**Correspondence Between  
Staff and Applicant  
Approval Letter**

15-ZN-2017  
Sienna Hills Ph. 2

RE: 6-GP-2017 and 15-ZN-2017  
Sienna Hills Phase II

RE: 6-GP-2017 and 15-ZN-2017  
Sienna Hills Ph. 2

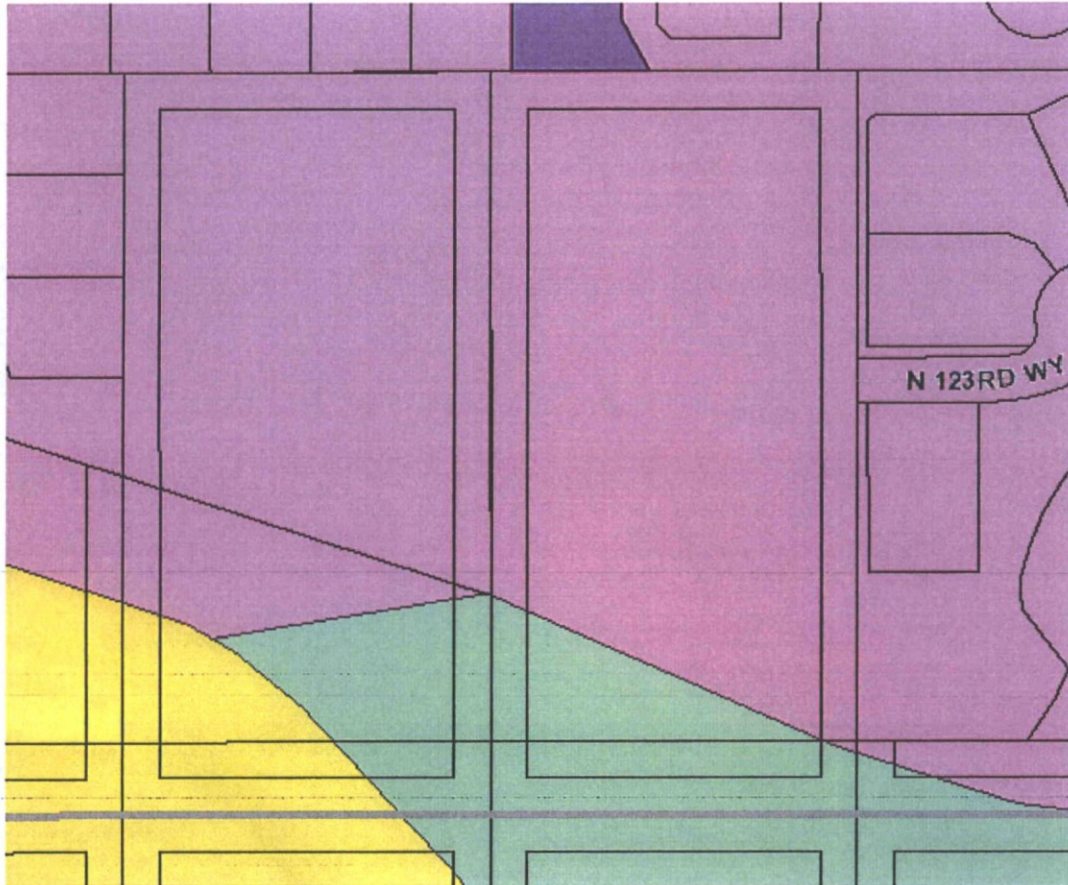
6. The subject property is in two Environmentally Sensitive Lands Landforms: Upper Desert and Lower Desert Landforms. Please revise the NAOS table on plans to show the area of the property in each landform with slope categories, percentages and required NAOS for each

landform. Please revise the NAOS calculations for Undisturbed and Disturbed NAOS based on revised required NAOS (Zoning Ordinance Section 6.1060). Please also revise the NAOS information in the narrative. These revisions may affect the overall NAOS provided including any excess that was anticipated to justify the future amended development standards request as part of the future preliminary plat submittal. See graphic below (pink indicates Upper Desert Landform and green indicates Lower Desert Landform):

*Response- NAOS calculations have been revised to show upper and lower desert.*
